Addendum 2: Global technical regulation No. 2

Measurement procedure for two-wheeled motorcycles equipped with a positive or compression ignition engine with regard to the emission of gaseous pollutants, CO₂ emissions and fuel consumption

Amendment 3 - Appendix 1

Authorization to develop amendments to gtr No. 2 (Motorcycles emissions)

Figure A13-1: Example of a gearshift sketch

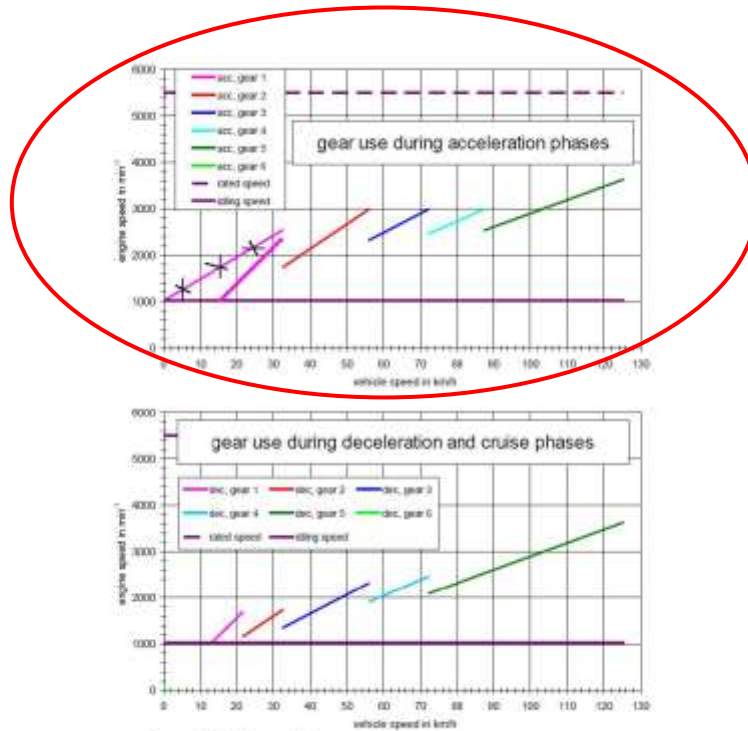
Paragraph 1., Figure A13-1, correct the line for "acc.gear 1" in the upper figure for "gear use during acceleration phases" as reproduced below:

- (b) Correction to ECE/TRANS/180/Add.2/Corr.2: Figure A13-1 in the Annex 13, paragraph 1 needs to be replaced reflecting actual use conditions.
2. The Working Party on Pollution and Energy (GRPE) agreed, at its sixty-fourth session, to the Proposal of Japan, to correct these editorial errors (described in the informal document No. GRPE-64-05). The proposal was submitted with document ECE/TRANS/WP.29/GRPE/2013/4 to GRPE for adoption at the sixty-fifth GRPE session in January 2013.
